LAUREATE PARK PHASE 6

SUMMARY

<p>Updated: March 23, 2015</p>

DEVELOPMENT PLAN

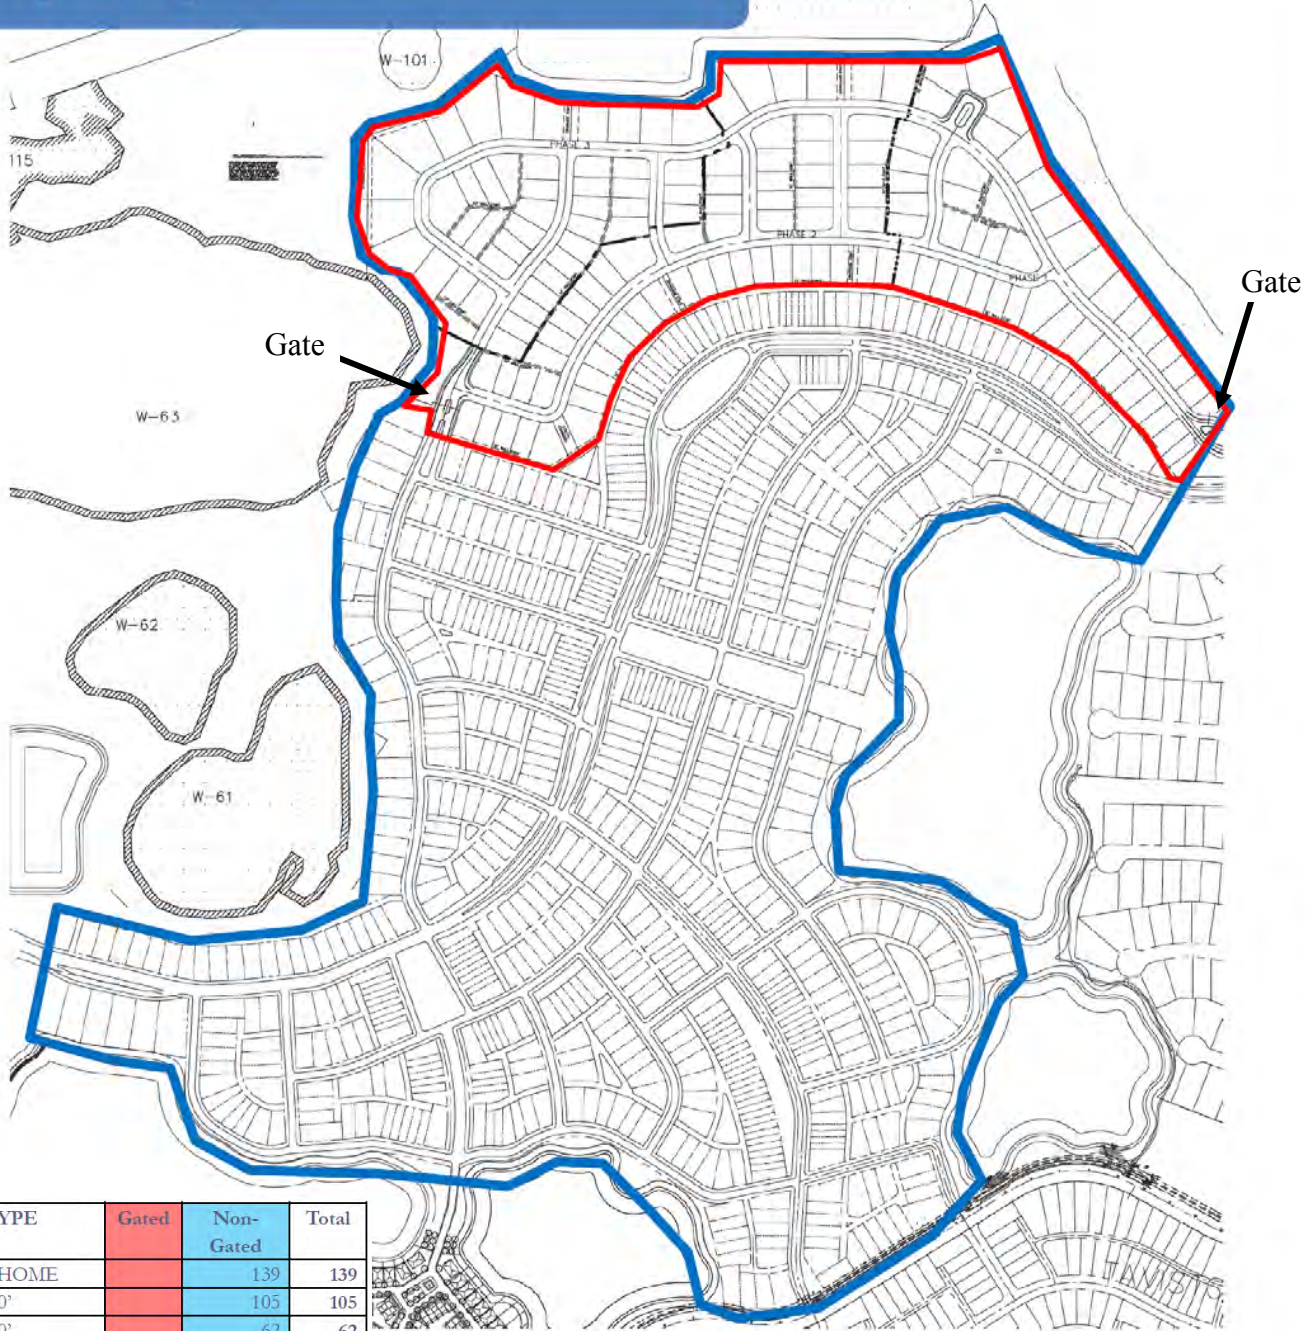
- If the lots south of Wetland #61 is rear loaded, add alley to the roadway map. This can be address at the Preliminary Plat stage.
- Show alley cross section for lot numbers 79, 80, 81, 251, 252, 253, 254, 255, 256, 382, 383, 384. This can be address at the Preliminary Plat stage.
- During the Preliminary Plat review, the City's Solid Waste Division and Fire Department shall review the alley conditions throughout the development to determine if a solid waste truck and/or fire truck can maneuver within the alleys.

road cross-sections key map

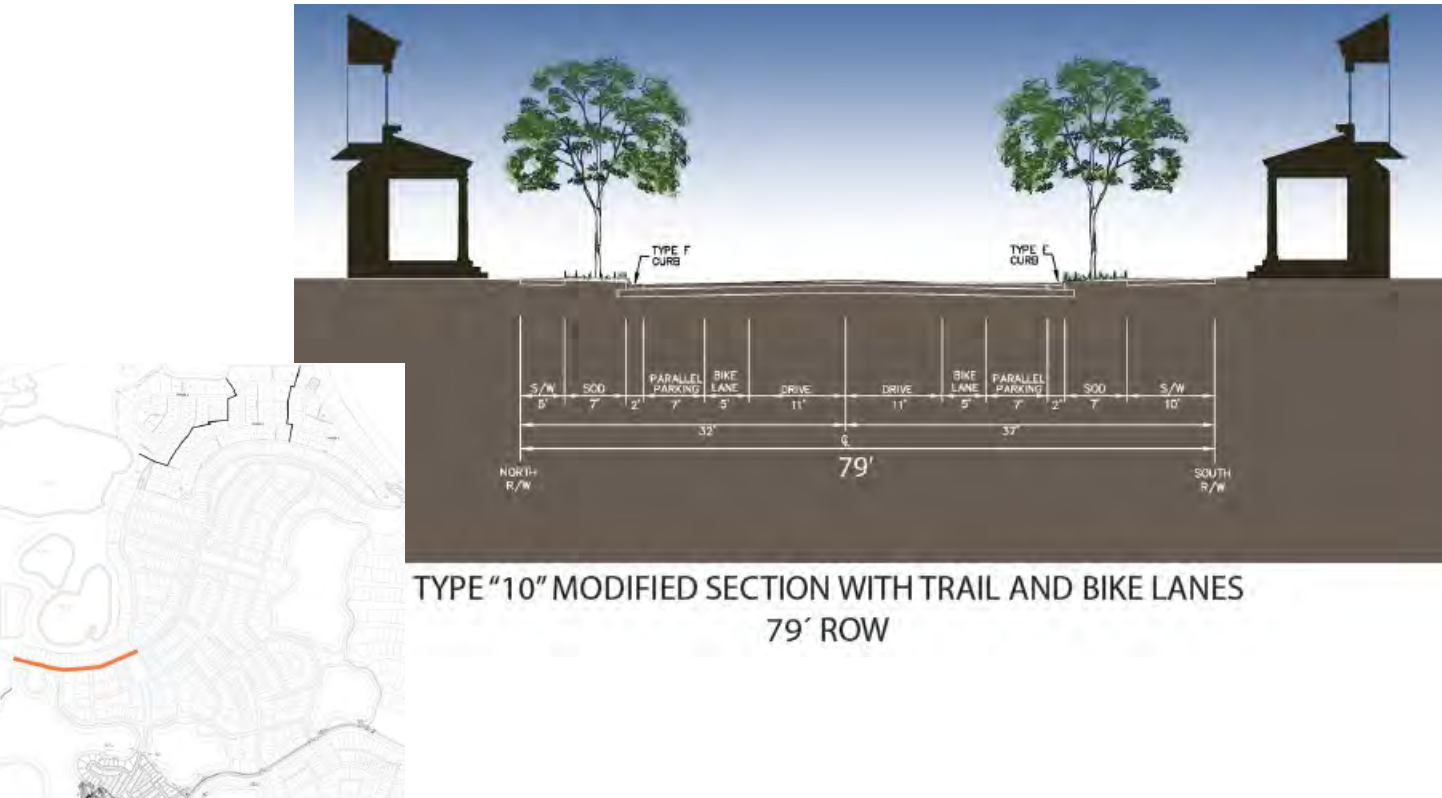
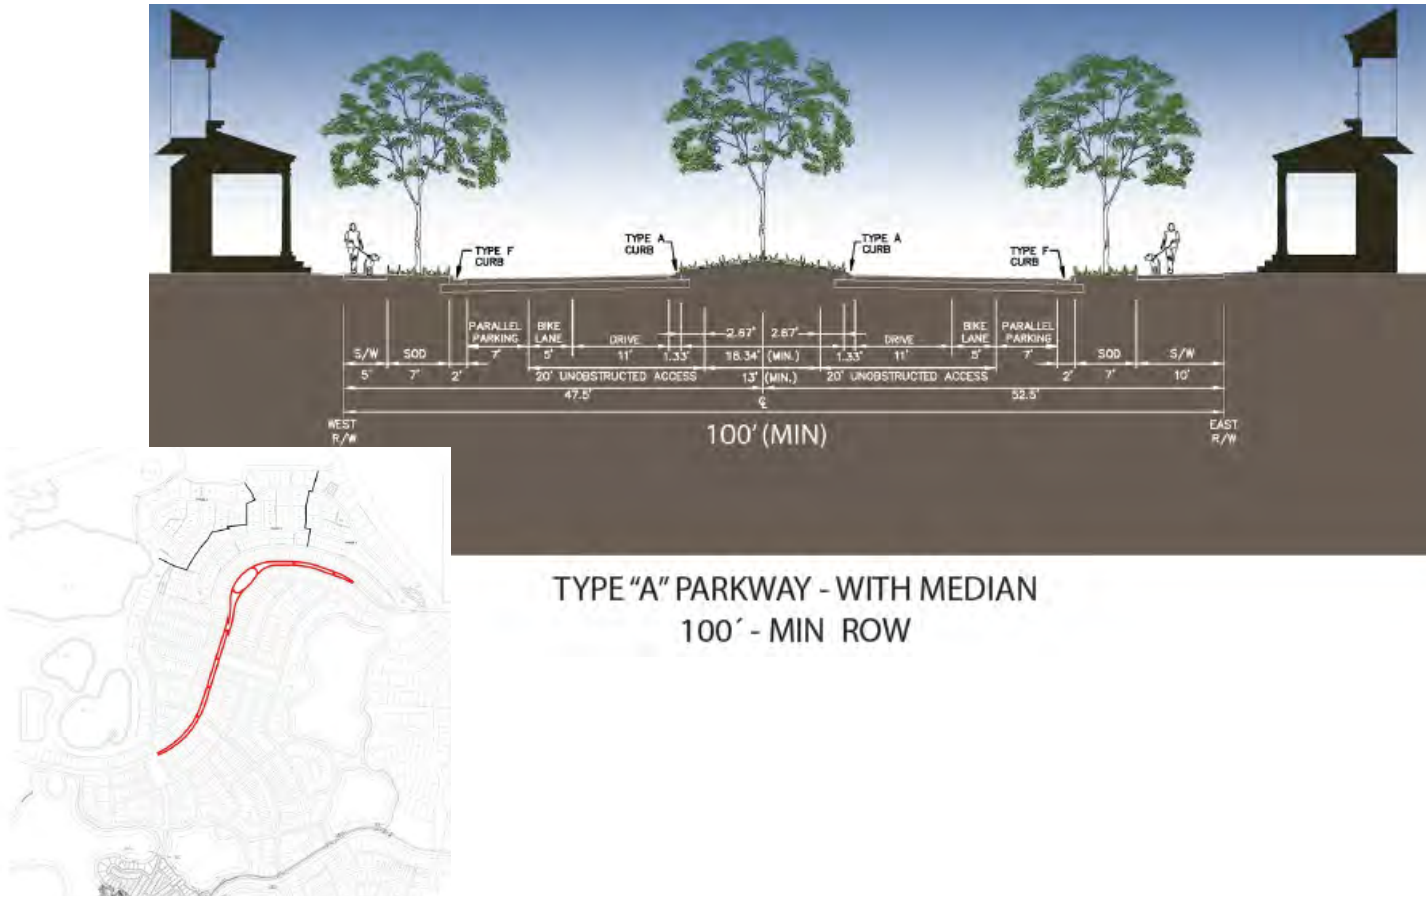
- The 4 short alleys serving the 11 lots facing onto the mews leading to the lakes on the east and west sides of the project shall be shown as Type 8 - 26' alleys.
- The divided Type 6 roadway leading to the west gated entrance to Phase 6 shall be modified to provide safer, direct access to the driveways of the 3 lots on the west side of the roadway OR a plan shall be provide to illustrate how the driveways for these lots will be configured.

TYPE "5" MODIFIED SECTION WITH TRAIL /PARKING
69' ROW

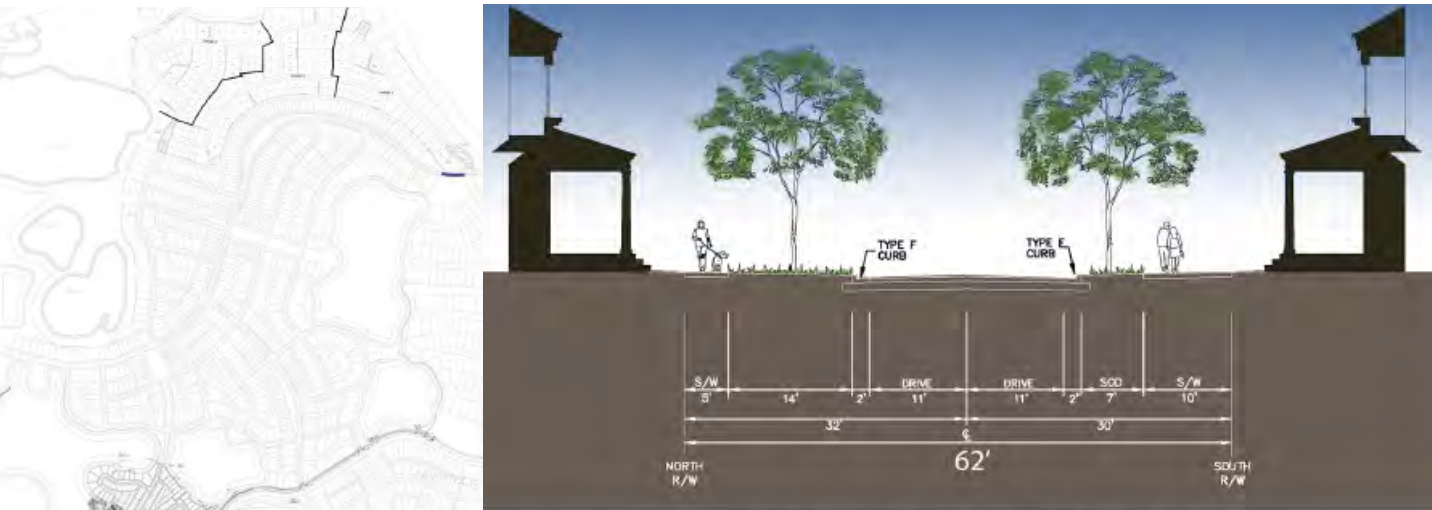
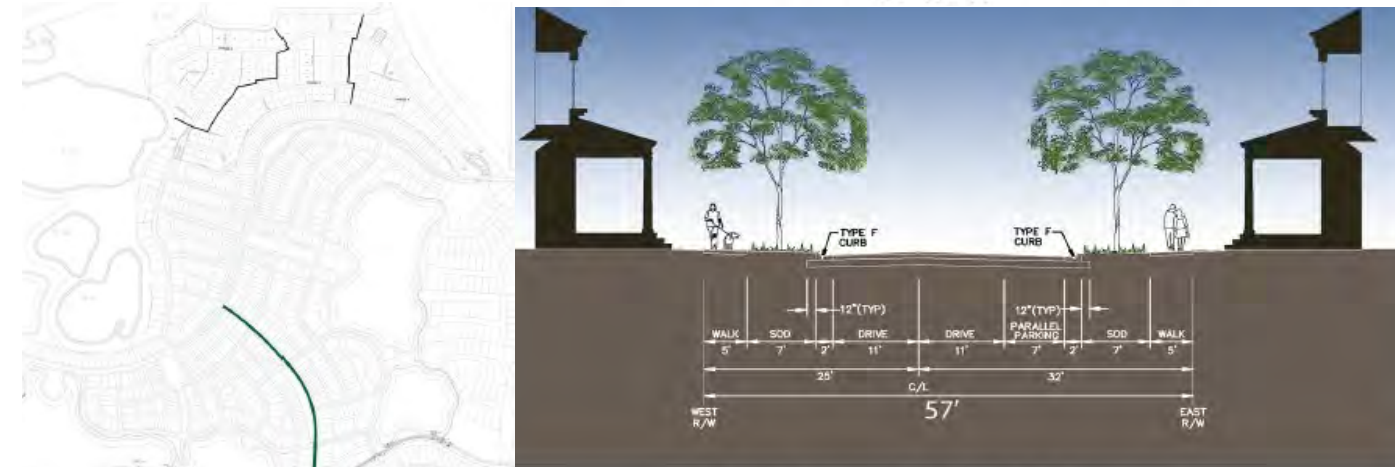
2. Section Type 5 w/Trail and w/o Trail:
 - Both of these sections shall include a 5' wide bike lane in each direction since they tie into Section Type A and are part of the main east-west roadway.

TYPE "B" PARKWAY ONE WAY
48,5' ROW

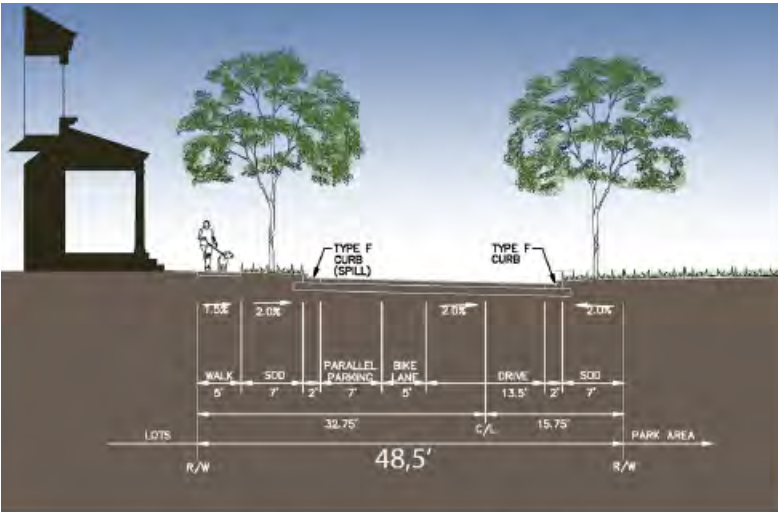
3. Section Type B:
 - The curb along the park shall be FDOT Type F. Flush curbs shall not be used outside of the alleyways.
 - A 5' sidewalk shall be provided on the park side of the road if a continuous sidewalk through the park is not constructed.
